RE: Structural Review of Relocation of Existing Heritage Listed Huts

ALTERATION AND RELOCATION OF TWO EXISTING HERITAGE BUILDINGS
UNITING CHURCH BRIGHTON CHILDCARE
Structural Condition Report

December 2024
Project No.: 24373
Revision No.: B

Figure 1: Load Bearing Wall Layout

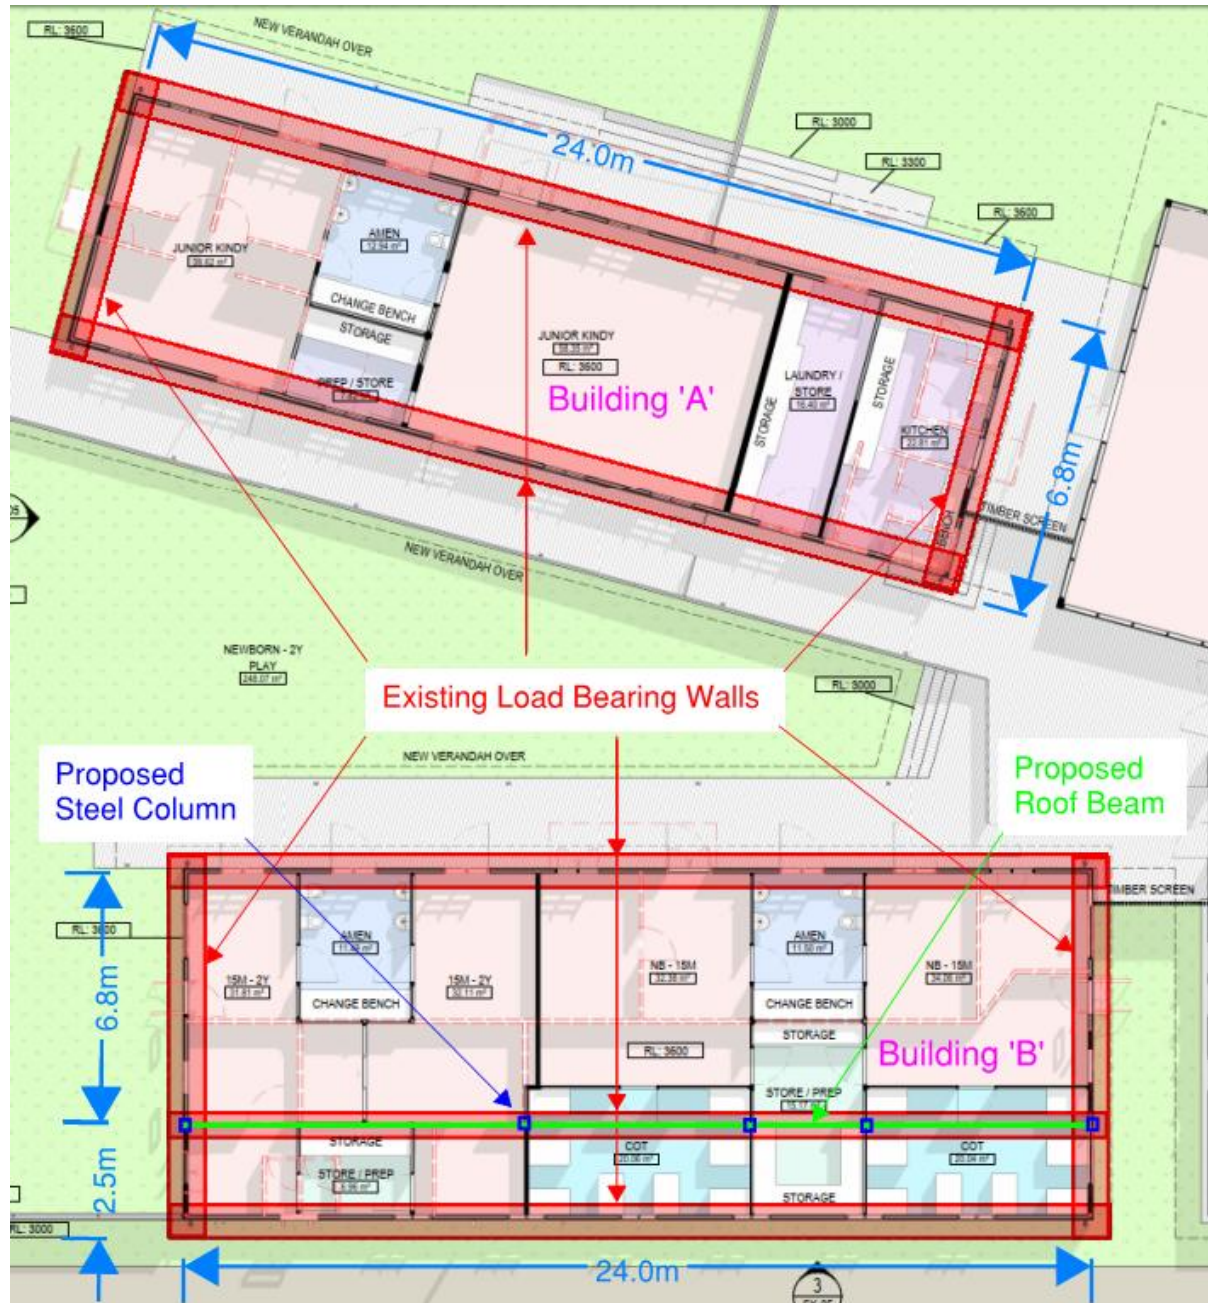
The existing wall framing was cover up with wall sheeting, hence the internal wall framing was not able to inspected. The internal area of the wall sheeting and ceiling appeared to be in adequate condition except for Building 'A' where the gable end wall which was observed to be damaged (Photo 7). Further assessment is required to examine the wall bracings, insulations and wall tie-downs between roof-wall and wall-floor framing. It is known that the internal walls are consider non-load bearing walls for Building 'A' as shown in figure below. Whereas for Building 'B', one of the internal walls is believed to be load bearing that is proposed to be

removed. Hence, we proposed to install new roof beam and columns or additional studs to replace the internal load bearing walls that will be removed in Building 'B'. Take note that the proposed roof beam might effect a down stand of the beam from ceiling or a bulkhead. Furthermore, the removal of internal wall with bracings shall be assessed and substituted to any new walls or to existing perimeter walls. It is also recommended to retrofit tie-down from the wall bottom plate to floor framing for both buildings.

Appendix A – Preliminary Sketch and Detail Markup

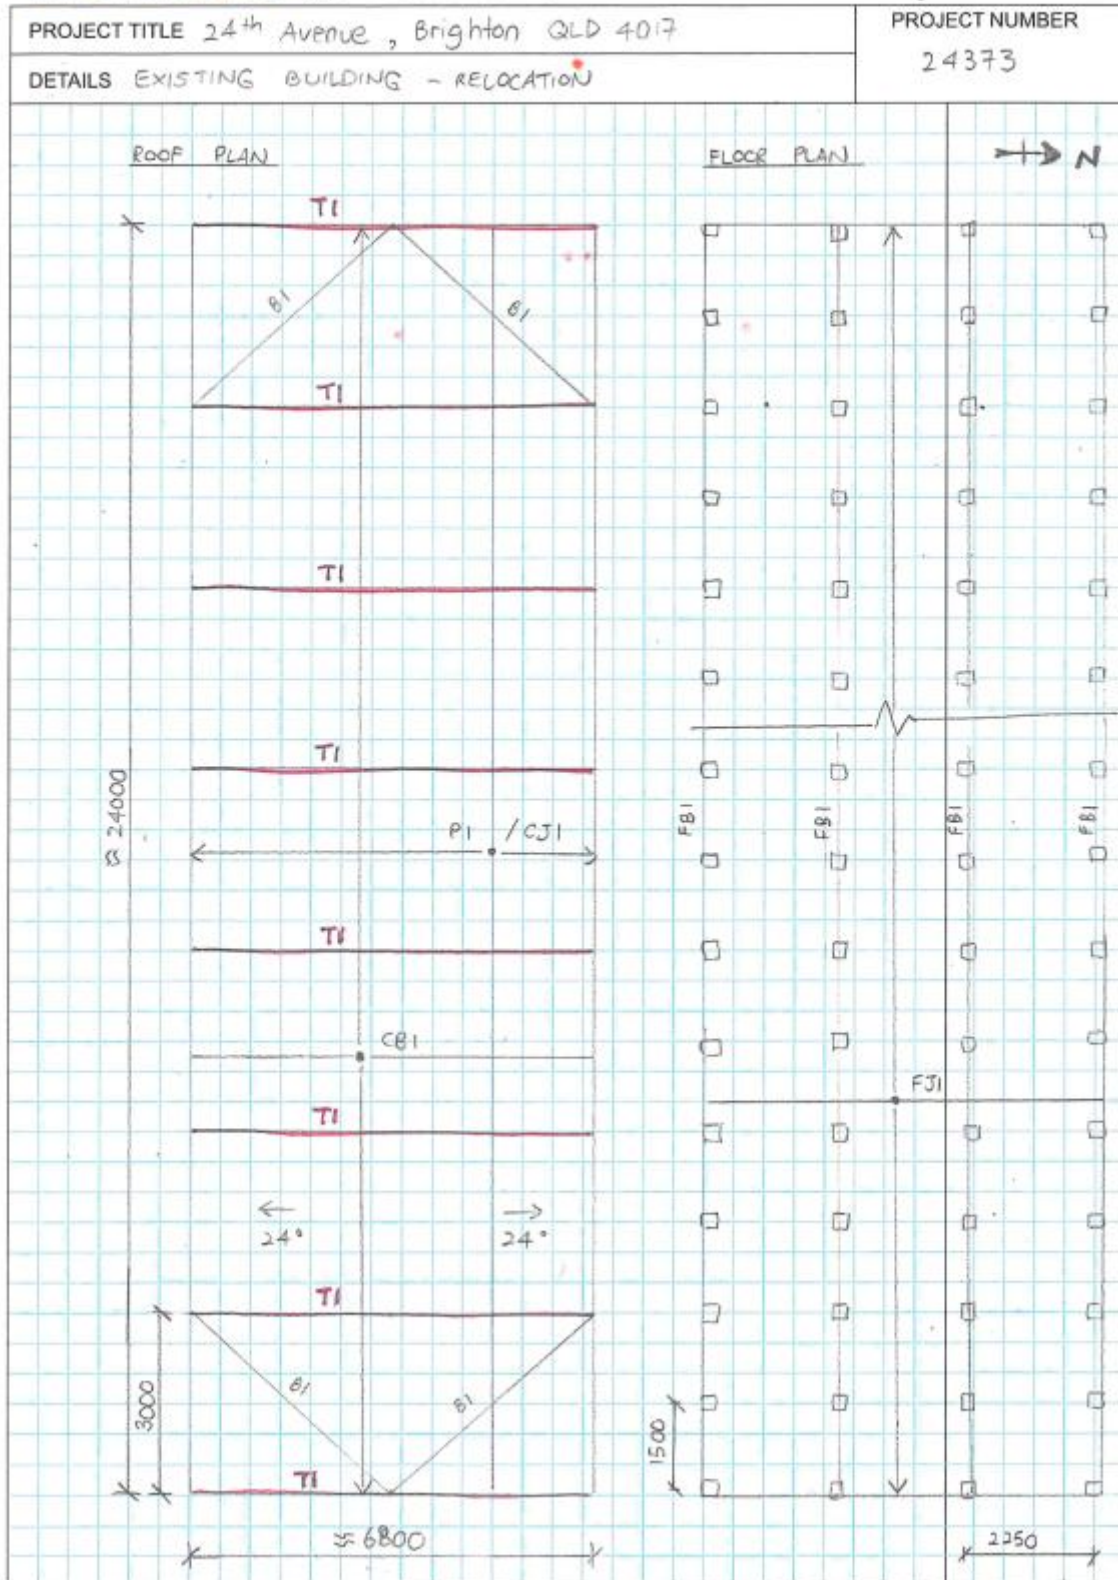
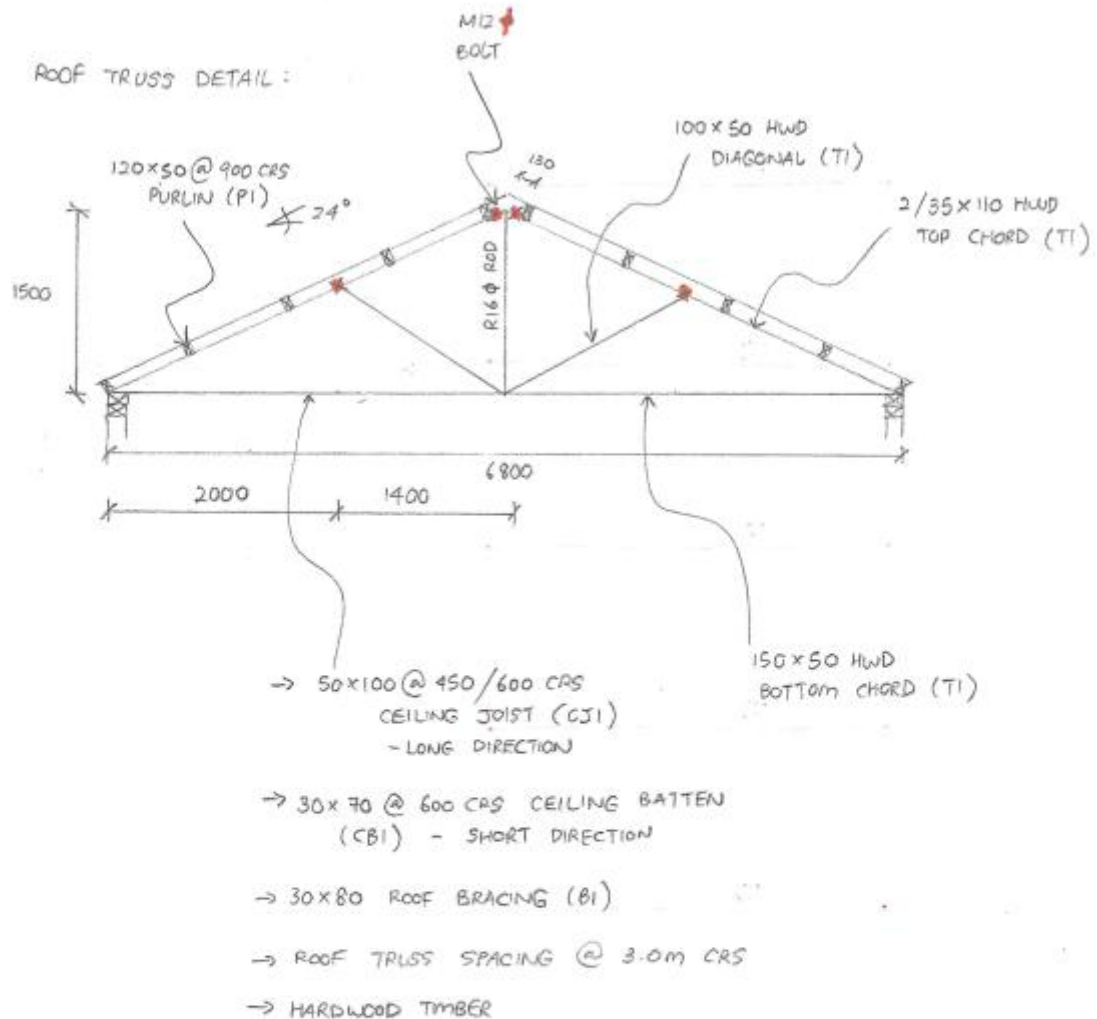
- 125 x 72 FLOOR BEARER (FBI)
- 50 x 100 @ 450/500 CRS FLOOR JOIST (FJI)
- HARDWOOD TIMBER
